Delegated Report

Householder Planning Application

Planning Application No: 20241009

Description: Retention of a hard standing for off road parking provision off a classified highway to the front of the Property.

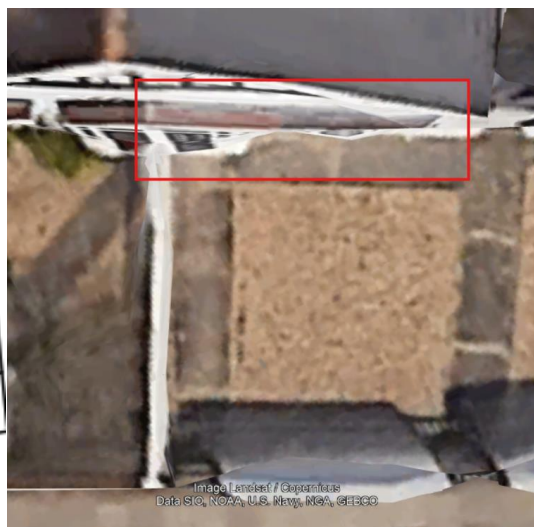
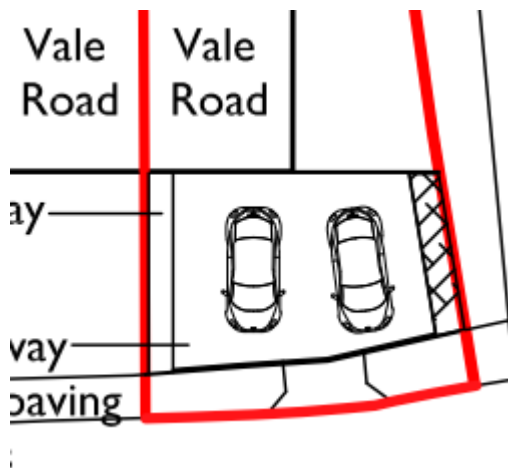
It is noted that the proposed elevation shows the front elevation incorrectly. The raised plant bed is not

shown within the property boundary.

The proposed block plan does not show the front projection of the property correctly; however, it is considered that the application can still be sufficiently determined.

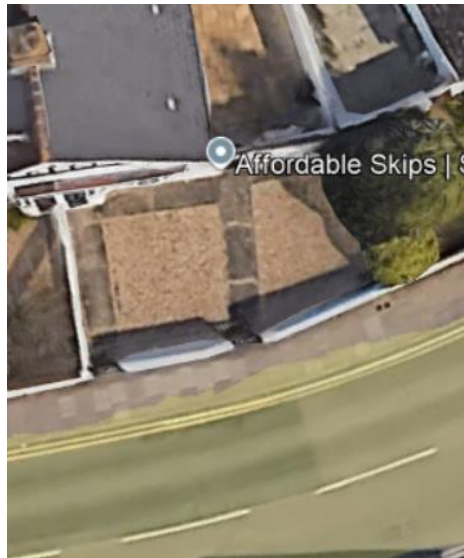
The driveway in its current form is considered to be unacceptable In terms of its design and appearance as it lacks greenery which would soften the existing urban appearance. The submitted plans show a raised plant bed which would be situated along the Eastern Boundary.

It is considered that this would soften the appearance of the hard paving and enable some on site biodiversity. Prior to the works taking place the property frontage comprised a gravelled area which did not enhance nor improve the appearance of the area.

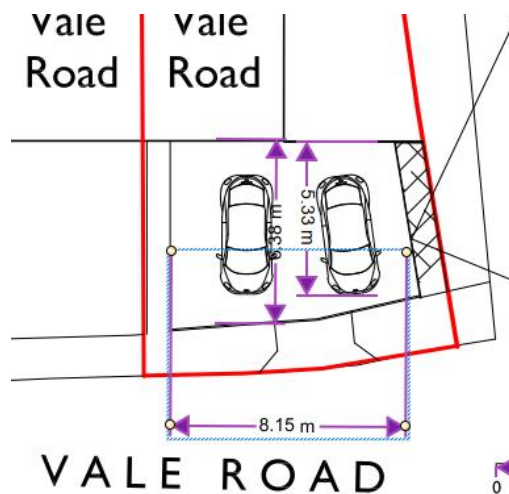
As can be seen below the driveway has adequate depth and width to satisfy the above and it is considered that the driveway is of an appropriate size.

In terms of visibility, whilst the submitted plans incorrectly show the splays, it is evident that sufficient splays can be achieved on site.

A condition will be imposed to ensure that there is a sufficient drop kerb installed and that there are no obstructions above 0.6m within the visibility splays.
